Accessibility Survey

City of Downey Old River School Road & Firestone Boulevard

Date of Inspection
5/25/2017

Prepared By
Disability Access Consultants
(800) 743-7067

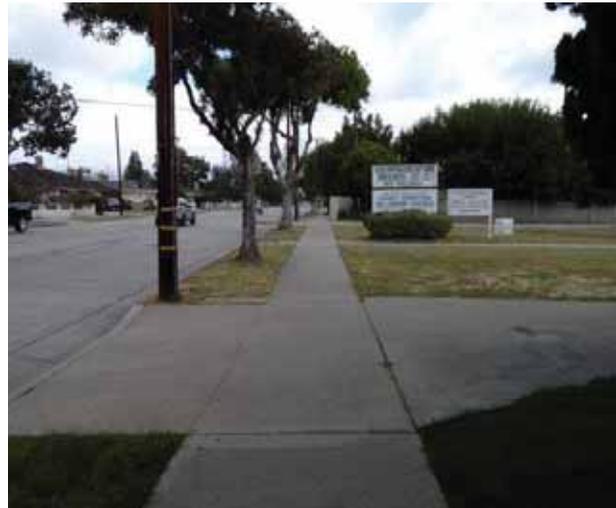
There are no detectable warnings where the pedestrian route crosses vehicular traffic.

On-Site Finding Not Found

Provide detectable warnings.

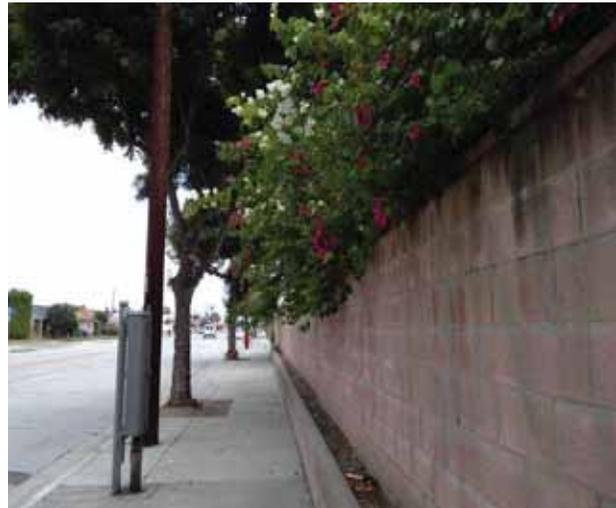
Overhead obstruction height is not compliant.

On-Site Finding 73.00 inches

Provide a compliant vertical clearance height.

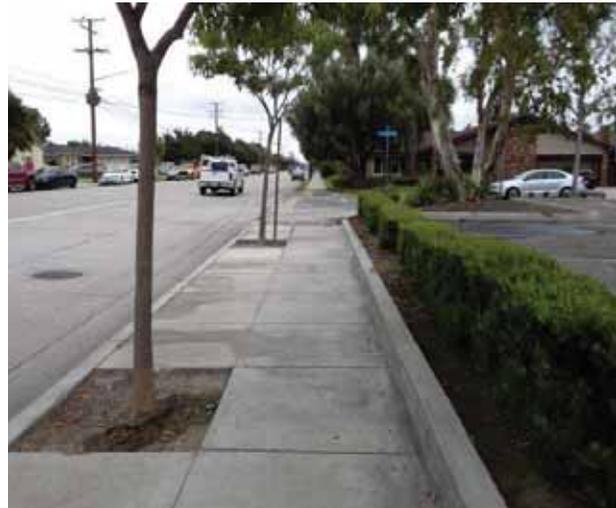
Sidewalk does not have enough width.

On-Site Finding 47.00 inches

Widen the sidewalk to the recommended value.

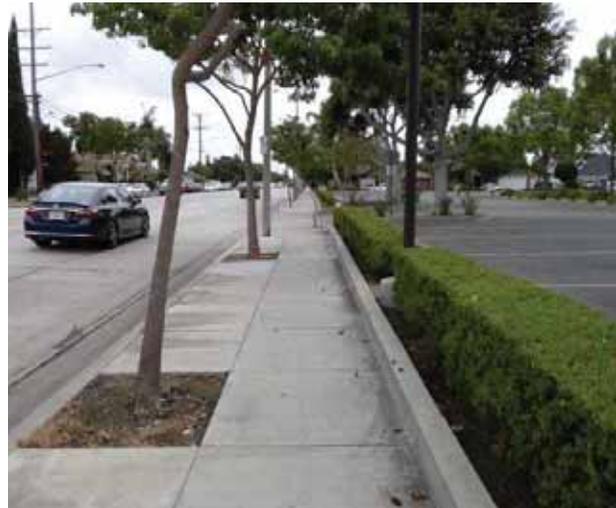
Sidewalk does not have enough width.

On-Site Finding 47.00 inches

Widen the sidewalk to the recommended value.
